Re: Petition No. 1558 - Community Power Group LLC petition for a declaratory ruling, pursuant to Connecticut General Statutes §4-176 and §16-50k, for the proposed construction, maintenance and operation of a 4-megawatt AC solar photovoltaic electric generating facility located at 24 Middle Road, Ellington, Connecticut, and associated electrical interconnection

Enclosed for filing with the Connecticut Siting Council ("Council") are 24 Middle Solar 1 LLC's responses to the Council's development and management plan interrogatories dated April 2, 2025.

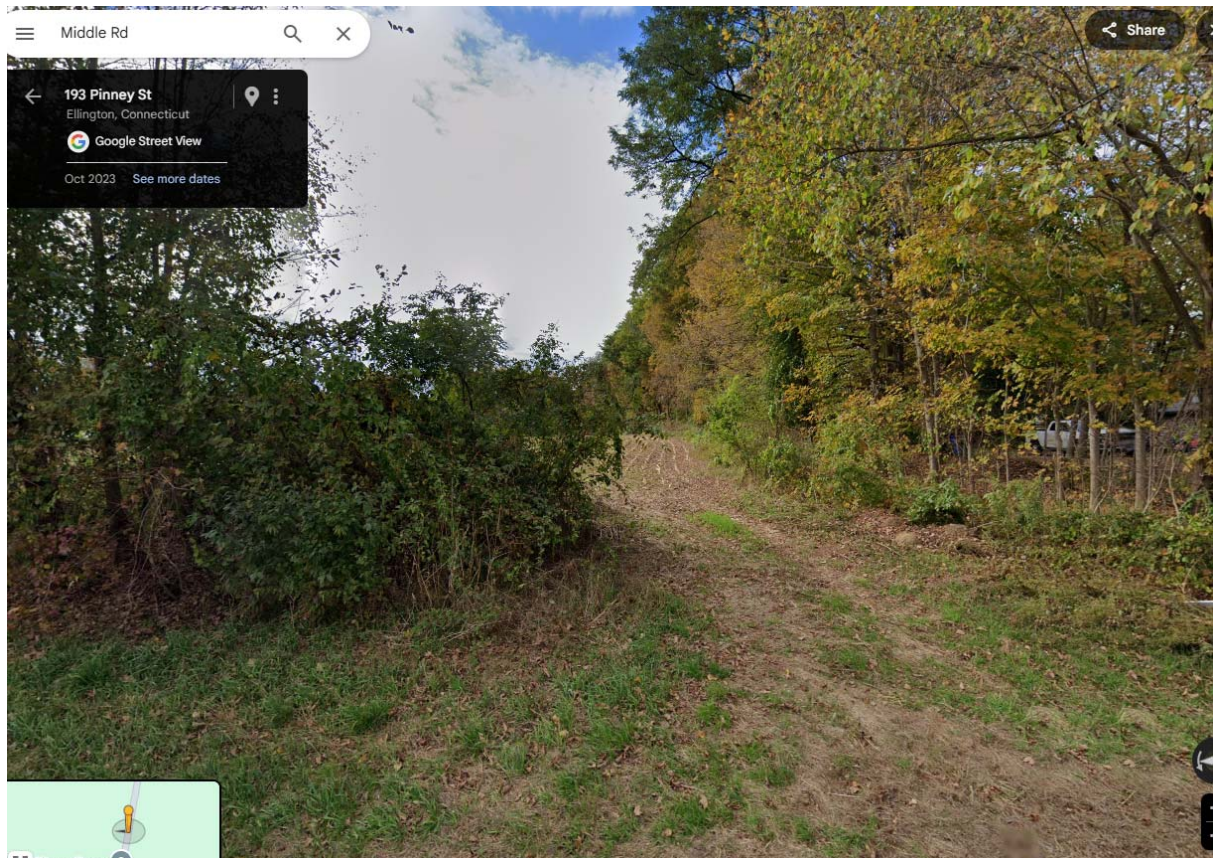
- b) What equipment will be on each of the 5 interconnection poles off Pinney Street?
- c) Why is an additional pole required on the east side of Pinney Street if there are two existing poles in close proximity?

- e) Describe the visibility of the interconnection area from Pinney Street and the residence/farm east of the interconnection access drive.
- f) Has CPG consulted with Eversource regarding the possible installation of underground lines and pad-mounted equipment on the customer side of the electric distribution interconnection, or other interconnection design(s), to further reduce visibility to the extent feasible?

- future transfer trip design, 3) a 600A utility disconnect switch, 4) a 15V pole-mounted recloser, and 5) a utility meter.
- c) The point of interconnection for the 24 Middle Solar Facility will be existing Eversource Pole #1209 which will be replaced as part of project construction by Eversource.

- e) There is existing vegetation along Pinney Street as shown in the screenshot below which will be maintained as much as possible to limit visibility of the interconnection area by surrounding homes, including the residence and farm east of the property. In addition, two evergreen trees will be added on either side of the site entrance to further limit visibility. Only when standing directly in front of the site entrance will the interconnection poles will be visible.
